HISTORIC AND DESIGN REVIEW COMMISSION

August 16, 2017

HDRC CASE NO: 2017-392
ADDRESS: 1314 MUNCEY
LEGAL DESCRIPTION: NCB 993 BLK 3 LOT E 14 OF S 50 OF N 100 OF 4 & W 91 OF S 50 FT OF N 100 FT OF 5 ORA29
ZONING: R-6 H
CITY COUNCIL DIST.: 2
DISTRICT: Government Hill Historic District
APPLICANT: Walter Stricker
OWNER: Walter Stricker
TYPE OF WORK: Construction of a rear addition, construction of a rear accessory structure
REQUEST:

NEW SOUTH ELEV.

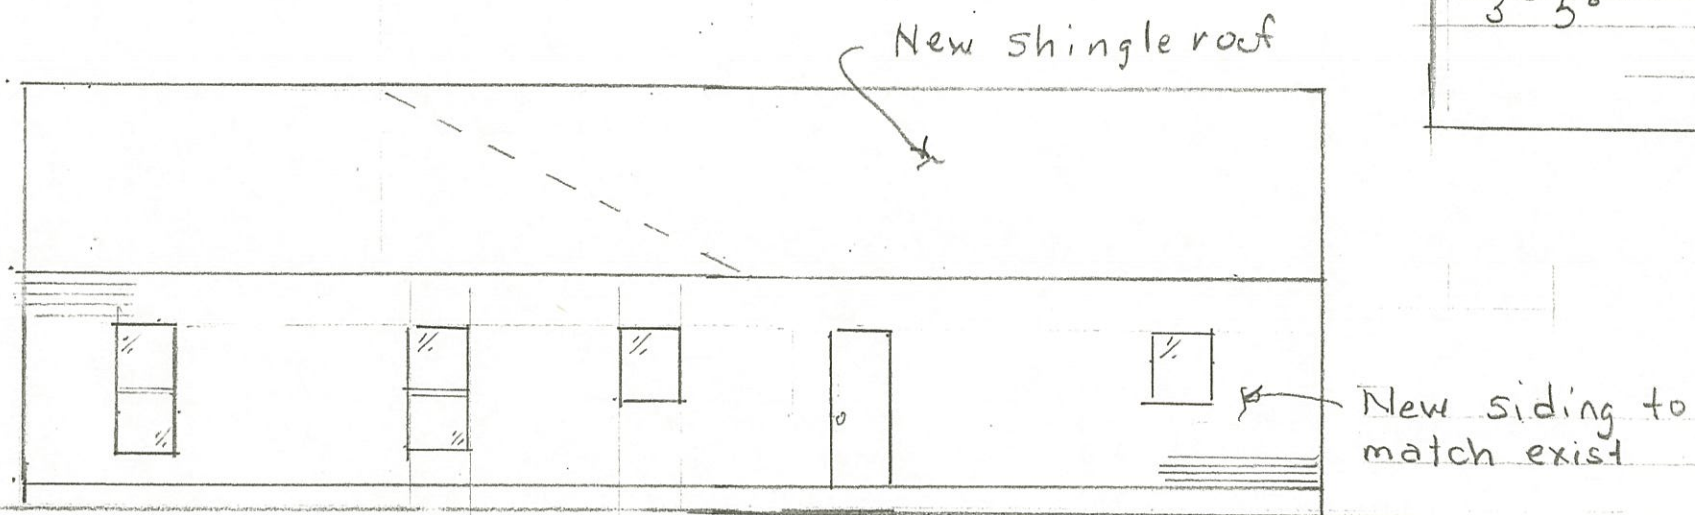
- c. **ROOF** – The existing rear elevation of the historic primary structure features a hipped roof. The proposed addition is 1-story in height and matches the existing roofline of the primary structure. The proposed addition will feature a gable roof on the rear elevation. The Historic Design Guidelines for Additions state that new additions should utilize a similar roof pitch, form, and orientation as the principal structure. While gable roofs are common for the Craftsman style, the primary historic structure was constructed with a rear hipped roofline. The proposed addition will eliminate this original roof form in favor of a simple shed gable. Staff finds the proposed roof form inconsistent with the Guidelines, as it eliminates a character defining feature of the original design.

- i. That the applicant modifies the rear addition roof configuration to incorporate a hip versus a gable as noted in finding c.
- ii. That double-hung, one-over-one wood windows or aluminum-clad wood windows be used based on findings f and g. Meeting rails must be no taller than 1.25” and stiles no wider than 2.25”. Color selection must be presented to staff. There should be a minimum of two inches in depth between the front face of the window trim and the front face of the top window sash. This must be accomplished by recessing the window sufficiently within the opening or with the installation of additional window trim to add thickness. Window trim must feature traditional dimensions and architecturally appropriate sill detail. Window track components must be painted to match the window trim or concealed by a wood window screen set within the opening.

STORAGE
NORTH ELEV.

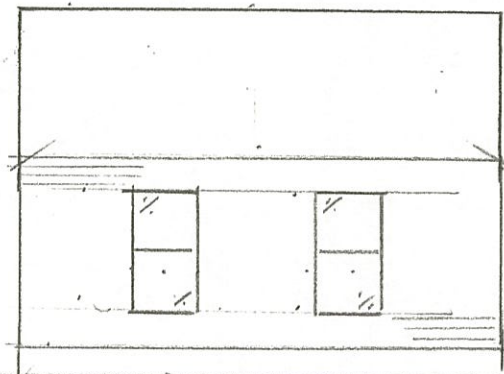
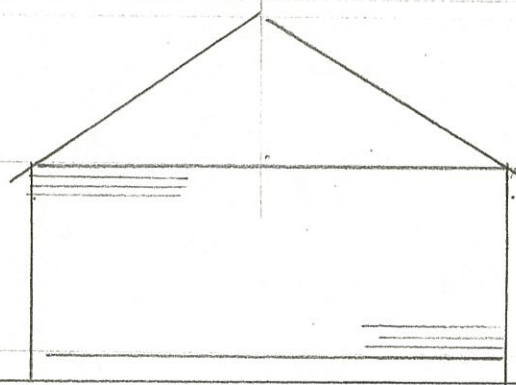
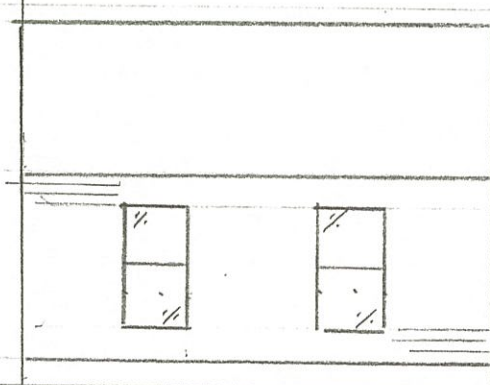
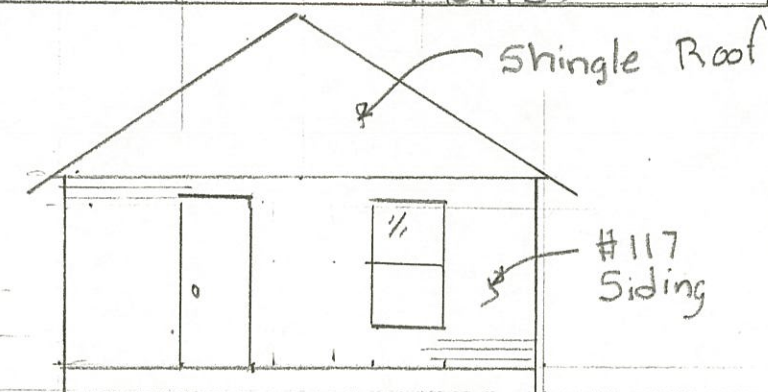
- m. **WINDOWS AND DOORS: SIZE AND PROPORTION** – The applicant has proposed to install five 3x5' one over one single hung windows and a 2'-6" x 7' door. According to the OHP Window Policy Document, windows used in new construction should maintain traditional dimensions and profiles found on the primary structure or within the historic district. Staff finds the proposal consistent with the Guidelines with the stipulations listed in the recommendation.

- n. **WINDOWS AND DOORS: MATERIALS** – According to the Historic Design Guidelines for Windows, windows used in new construction should maintain traditional dimensions and profiles, be recessed within the window frame, feature traditional materials or appearance, and feature traditional trim and sill details. Based on the documentation provided, the proposed windows are vinyl. This is not consistent with the Guidelines.

- i. That double-hung, one-over-one wood windows or aluminum-clad wood windows be used based on finding m and n. Meeting rails must be no taller than 1.25” and stiles no wider than 2.25”. Color selection must be presented to staff. There should be a minimum of two inches in depth between the front face of the window trim and the front face of the top window sash. This must be accomplished by recessing the window sufficiently within the opening or with the installation of additional window trim to add thickness. Window trim must feature traditional dimensions and architecturally appropriate sill detail. Window track components must be painted to match the window trim or concealed by a wood window screen set within the opening.
- ii. That the applicant complies with all setback standards as required by zoning.

NEW PLAN

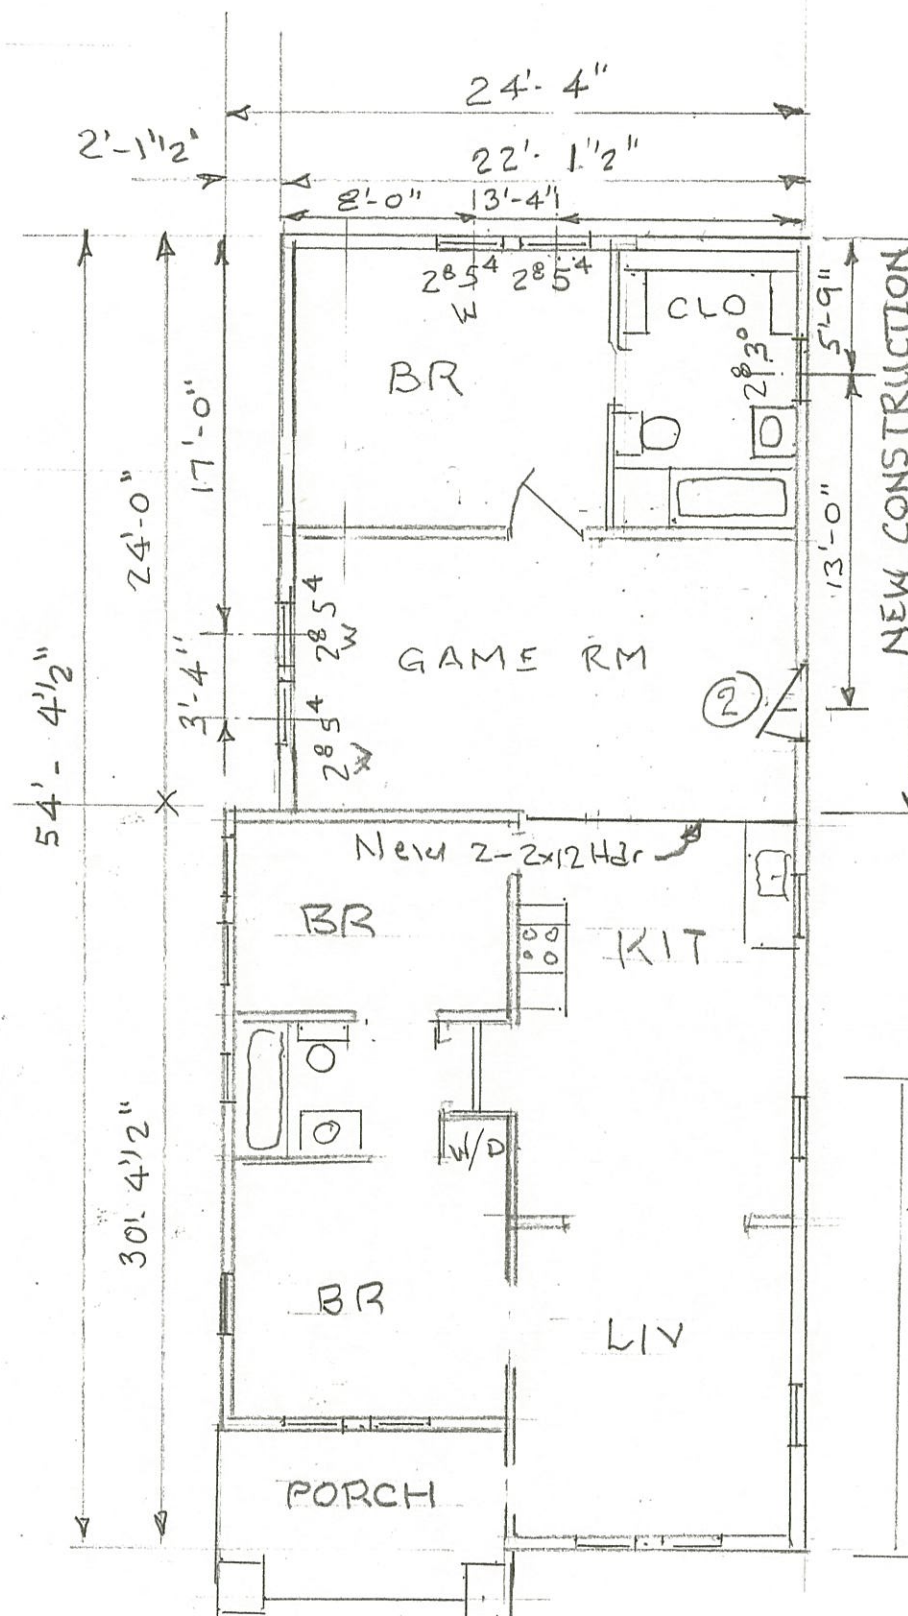
- b. **MASSING AND FOOTPRINT** – The applicant has proposed to construct a rear addition to the primary structure. According to the Historic Design Guidelines, additions should be located at the rear of the property whenever possible. Additionally, the Guidelines stipulate that additions should not double the size of the primary structure. The proposed addition approximately doubles the size of the primary structure. However, the historic structure has a small footprint relative to other historic homes in the area. Homes of the proposed total area are not common in the vicinity, and historic homes designed in the Craftsman style feature larger footprints across the city. Staff

- i. **TRANSITIONS BETWEEN OLD AND NEW** – The proposed addition will be inset on the north façade from the historic structure by approximately 2 ½ feet. According to Guideline 2.A.v for Additions, rear additions should utilize setbacks, a small change in detailing, or a detail at the seam of the historic structure and addition to provide a clear visual distinction between old and new building forms. The proposal meets this Guideline.

- iii. That the applicant submits final documents with all dimensions indicated to staff prior to receiving a Certificate of Appropriateness.
- iv. That the applicant complies with all setback standards as required by zoning.
